DPC

OCONEE 1

SUPPLEMENT 1 TO IMPROVED TECHNICAL
SPECIFICATIONS SUBMITTAL

ENCLOSURE 1

EXAMPLE B3.06-3

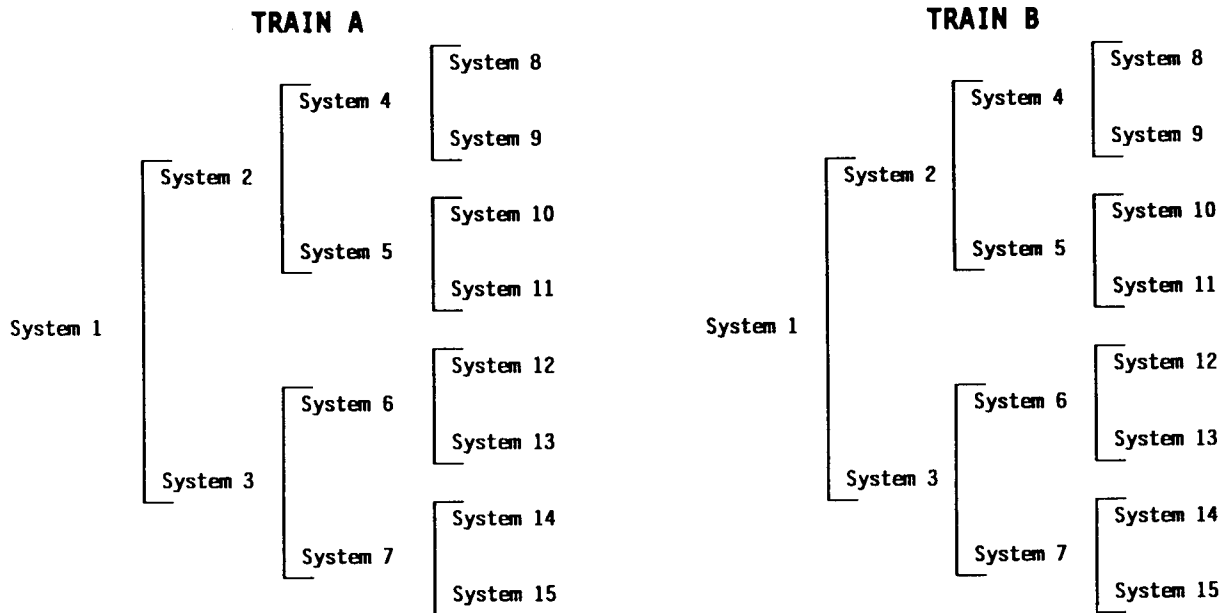
If System 2 of Train A is inoperable, and System 1 of Train B is inoperable, a loss of safety function exists in Systems 2, 4, 5, 8, 9, 10 and 11.

Minimum Qualifying
Figure 3.7.12.1 (page 1 of 1)
Burnup versus Enrichment Curve for
Spent Fuel Storage Racks
Initial
Unrestricted Storage in the
Units 1 and 2
(pool)
(2)

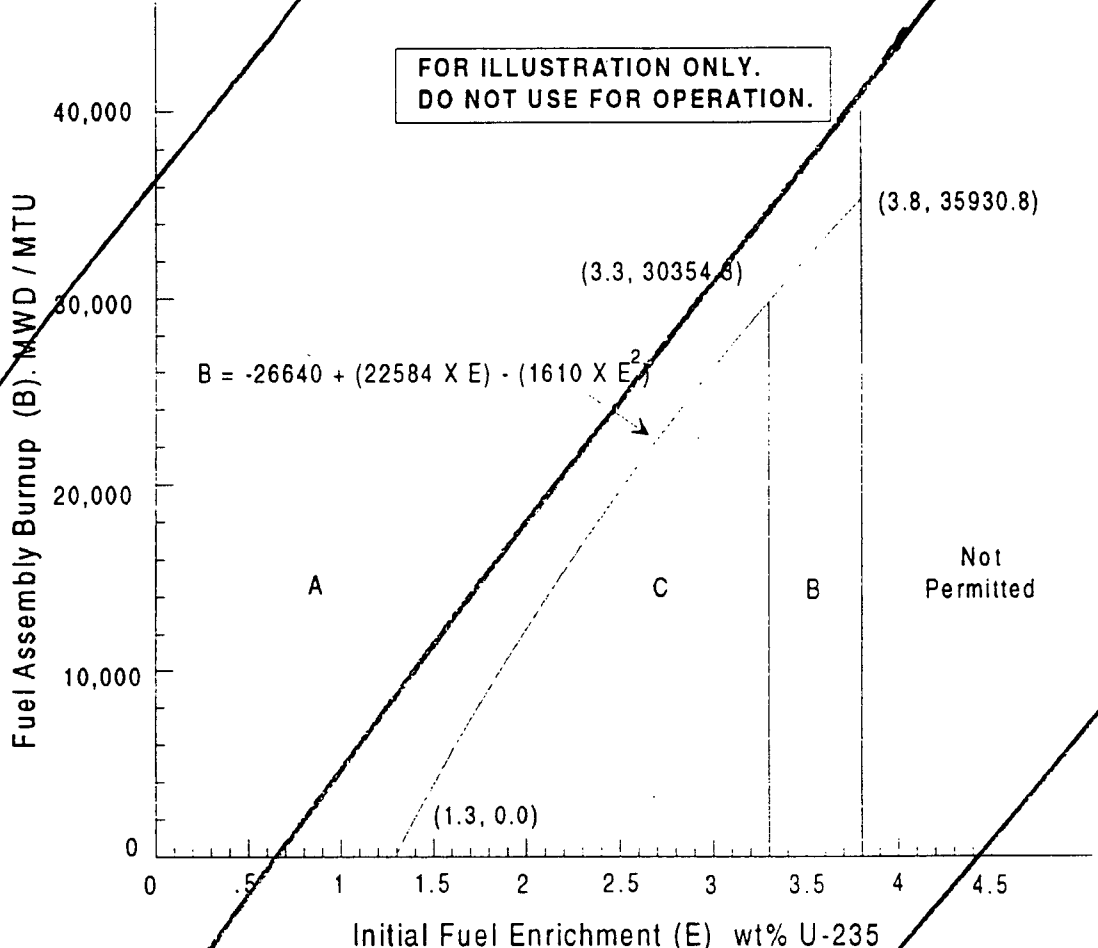
LCO 3.7.16.1 The combination of initial enrichment and burnup of each spent fuel assembly stored in [Region 2] shall be within the acceptable [burnup domain] of Figure 3.7.16-1 or in accordance with Specification 4.3.1.1.

SURVEILLANCE	FREQUENCY
<p>SR 3.7.16.1</p> <p>Verify by administrative means the initial enrichment and burnup of the fuel assembly is in accordance with Figure 3.7.16-1 or Specification 4.3.1.1</p>	<p>Prior to storing the fuel assembly in [Region 2] the spent fuel pool.</p>
